bb-ldo — Design Document

ai-ee v1 pipeline
generated 2026-08-19 02:39:45

learning block-basics: a linear regulator. Input 5 V DC on a screw terminal; output 3.3 V at up to 500 mA on a screw terminal. Must hold regulation at full load with no airflow. Workspace boards/bb-ldo.

reports/renders/bb-ldo_top.png

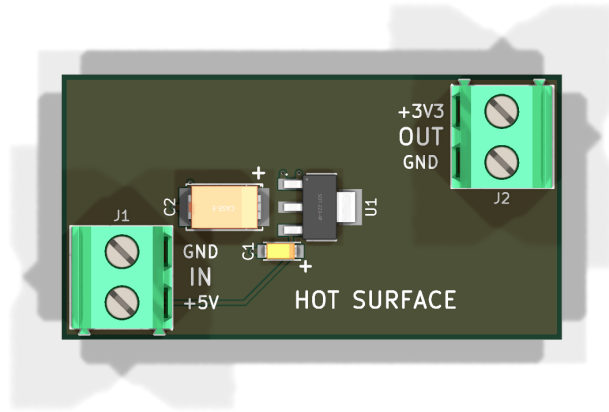
Connector orientation - the top-down render lies about this. In `bb-ldo_top.png` both terminals appear to have their wire openings facing the board interior, which would be a serious defect. They do not. Three independent artifacts agree that both wire entries face **outward**: (a) the WRL mesh has two 4.0 x 5.5 mm rectangular openings centred exactly on the pin x-positions on the footprint -y face and nothing comparable on +y; (b) the footprint's two silk arrows sit on that same -y face pointing inward, the standard wire-insertion marking; (c) `bb-ldo_left.png`, rendered for this review, shows J1's cage openings squarely facing the camera at -X while J2 presents its back. J1's entry face is 0.86 mm inside the left board edge, J2's 0.86 mm inside the right. **Correct.** What the top view shows on the inboard faces is a shallow moulded recess, not a hole.

Capacitor polarity, after assembly. C2's added + at (24.800, 29.400) is directly over pad 1 at x=24.788 - the anode, on +3V3 - 0.52 mm clear of the body silk and outside the courtyard, so it is visible with the part fitted (`bb-ldo_top.png`, and the zoomed body in the centre crop shows the model's own light anode stripe on that same right-hand end, agreeing with the mark). C2's native marks are indeed useless: the band at local x=+2.20 is under the 7.3 x 4.3 body and the pin-1 dot is a 0.03 mm radius circle. C1 needs no added mark - its footprint's own + glyph lands at (29.500, 38.810), outside its courtyard on the anode side, and its model stripe agrees. ****Both correct and both legible.****

reports/renders/bb-ldo_bottom.png

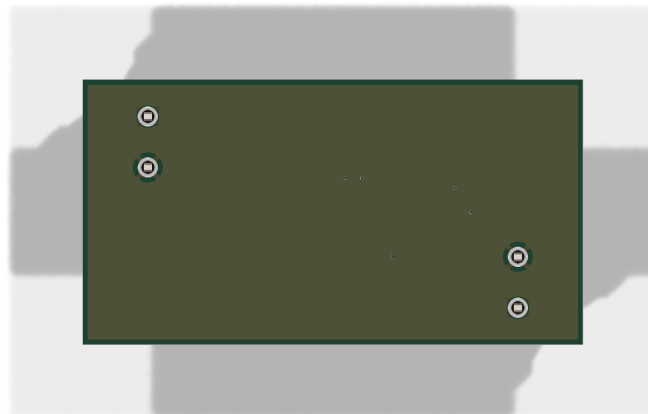
- J1.2 (GND) and J2.2 (GND) are both `thru_hole` pads with (`layers "*.Cu" "*.Mask"`), i.e. their barrels penetrate F.Cu and B.Cu directly. Confirmed visually in `bb-ldo.bottom.png`: both show a four-spoke thermal relief into the plane, while J1.1 (+5V) and J2.1 (+3V3) show an isolating antipad.

Hand-solder access. J1 and J2 are the only hand-soldered parts and they solder from the bottom, where B.Cu carries nothing but the GND plane and three tented vias - no SMT parts, no obstructions (`bb-ldo_bottom.png`). C1 and C2 are on the opposite face, 8.3 mm and further from the nearest THT pin; ****an iron at J1 or J2 cannot reach them.**** The only hand-solder problem on this board is F3.
